ADDENDUM NO. 1

July 28, 2022

Silver Creek High School Additions & Renovations
557 Renz Avenue
Sellersburg, IN 47172

This Addendum forms a part of and modifies the Bidding Requirements, Contract Forms, Contract Conditions, the Specifications and the Drawings dated July 8, 2022, by CSO Architects. Acknowledge receipt of the Addendum in the space provided on the Bid Form. Failure to do so may subject the Bidder to disqualification.

MATERIAL LEGEND

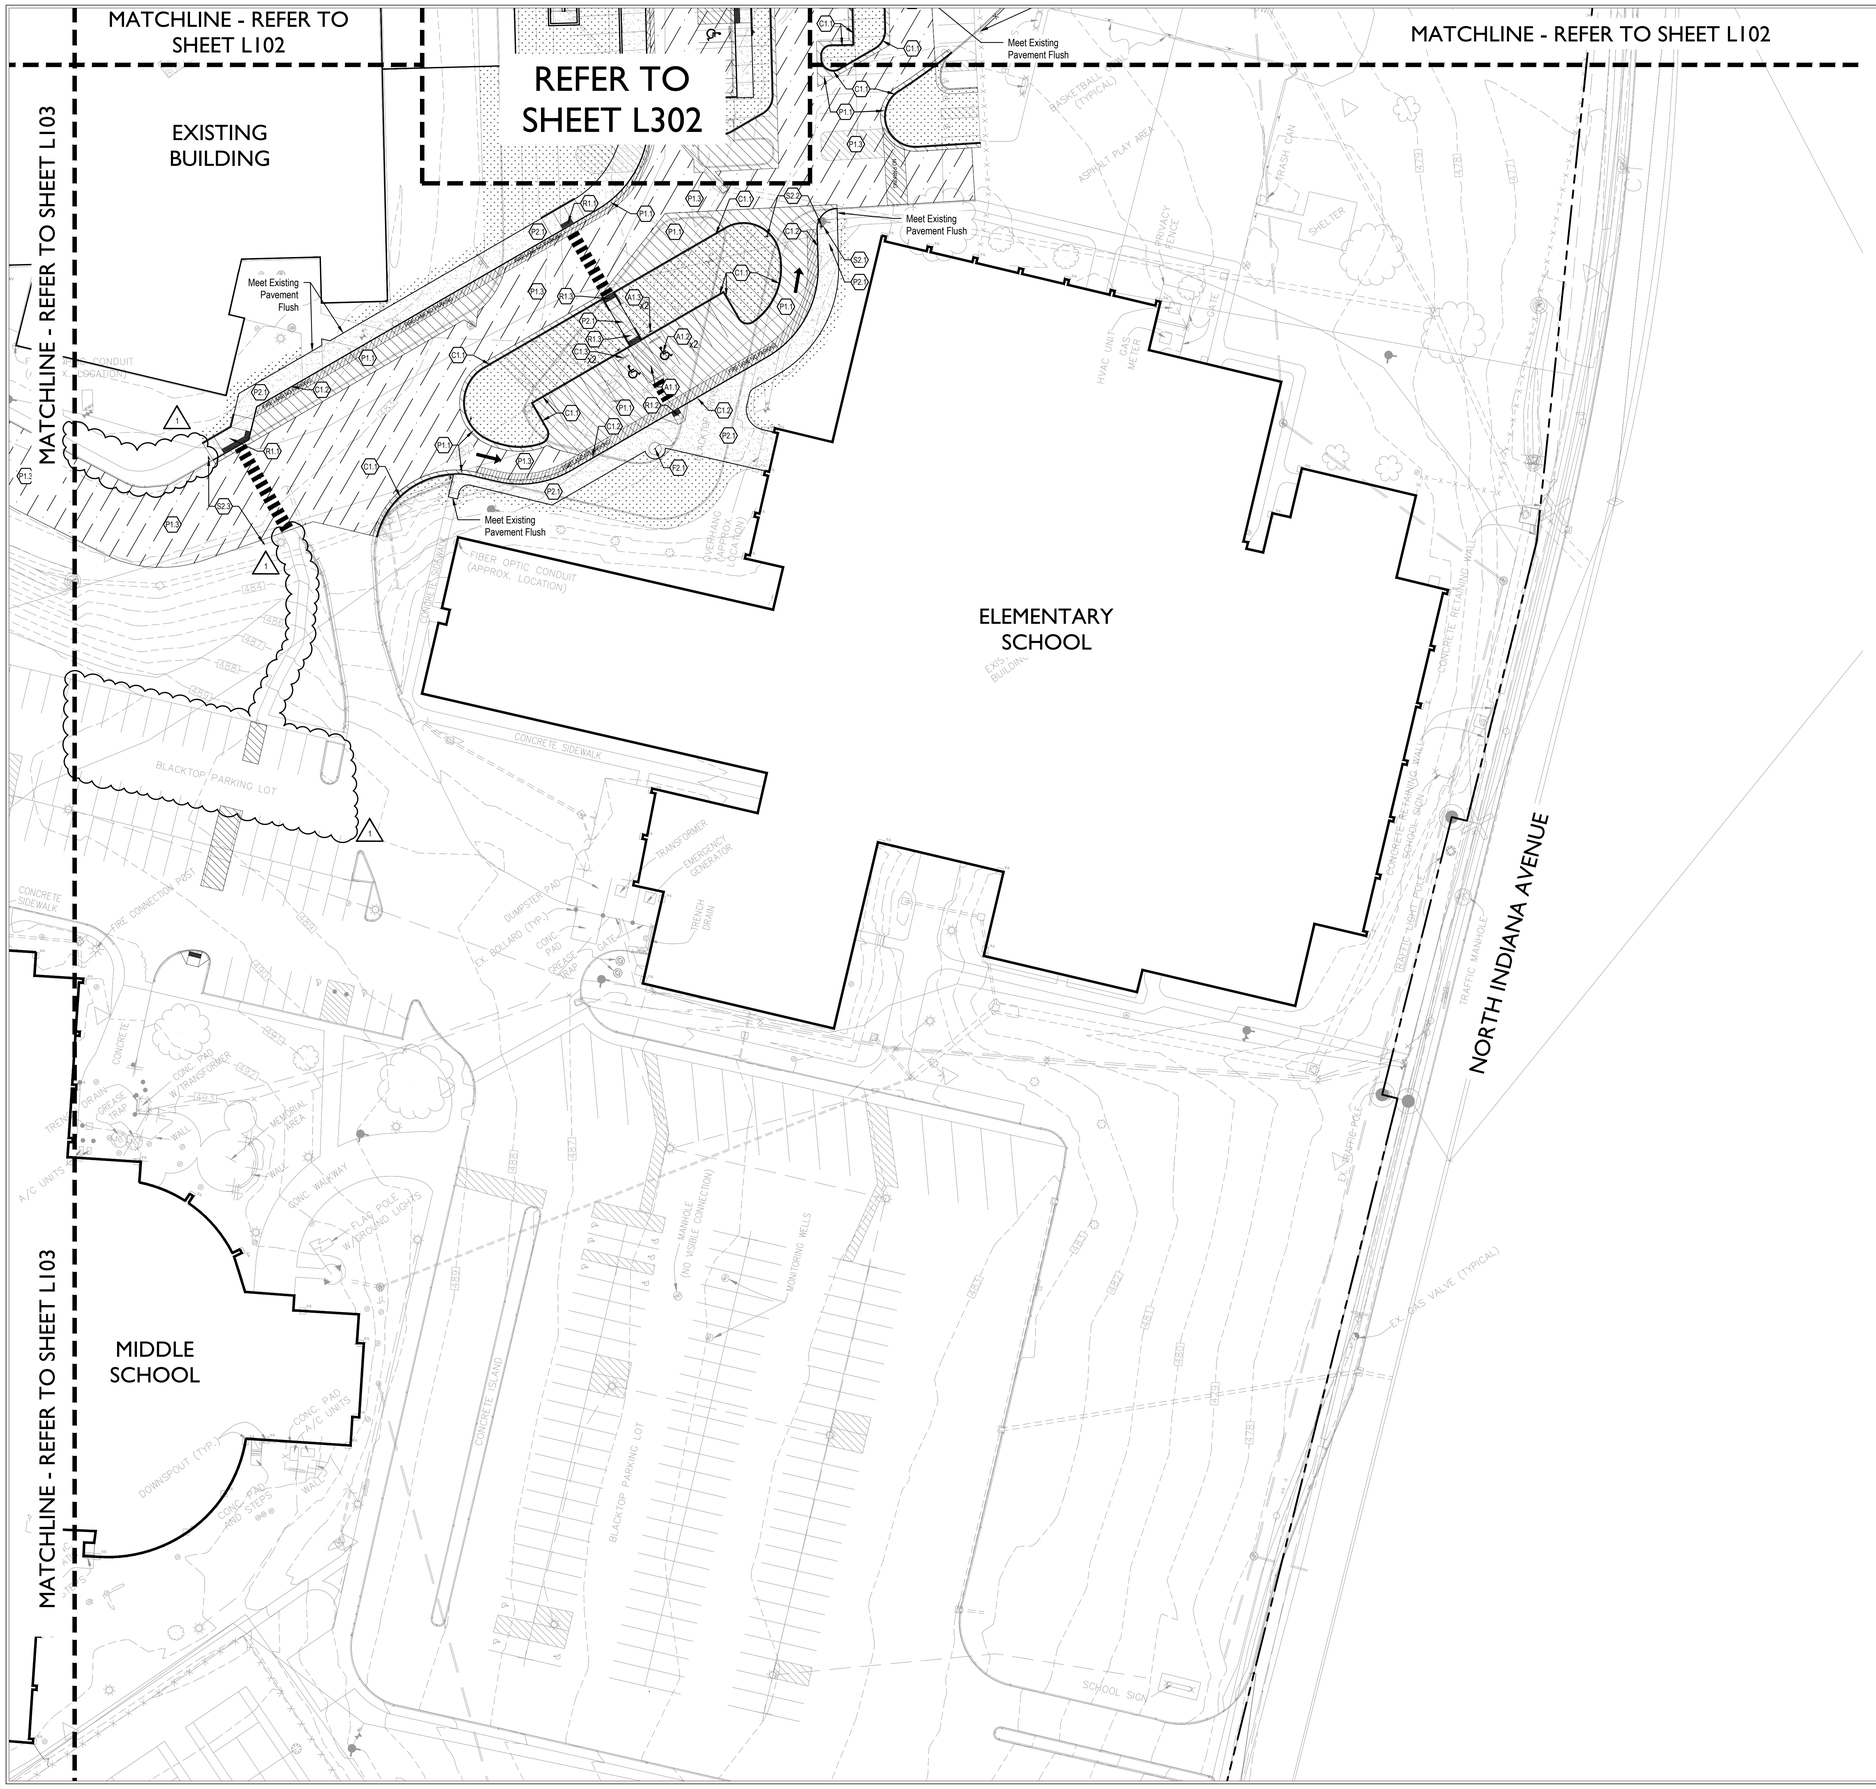
A. Detail 11/L502 COURTYARD CONCRETE PAD & RISERS added to Project.

1 A228 FIRST FLOOR REFLECTED CEILING PLAN - UNIT H
SCALE: 1/8" = 1'-0"

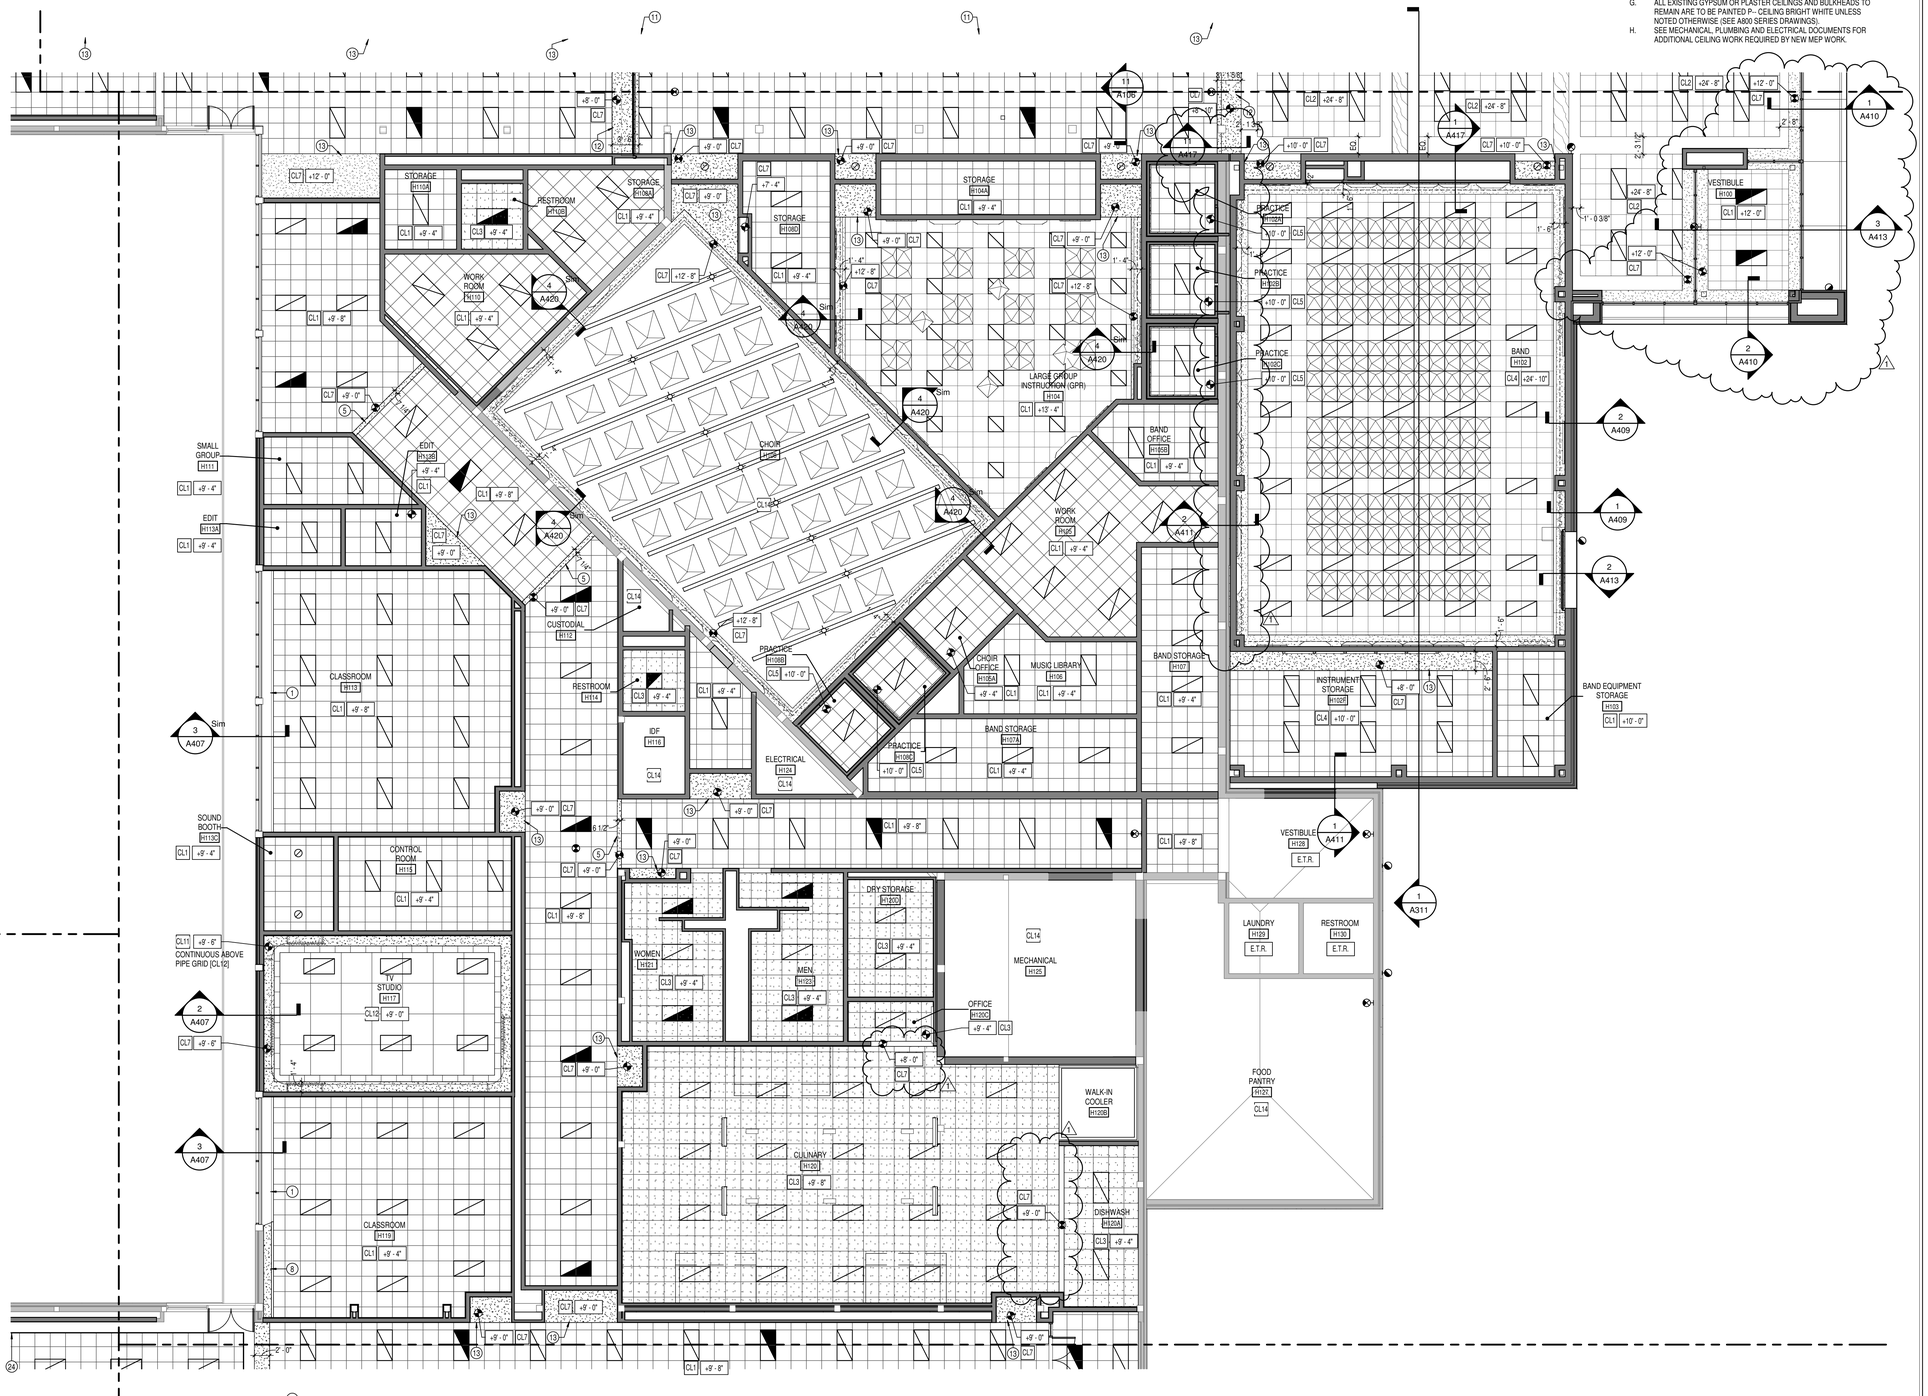
D. Revise reflected ceiling plan around VESTIBULE H100 as clouded on attached sheet A228.
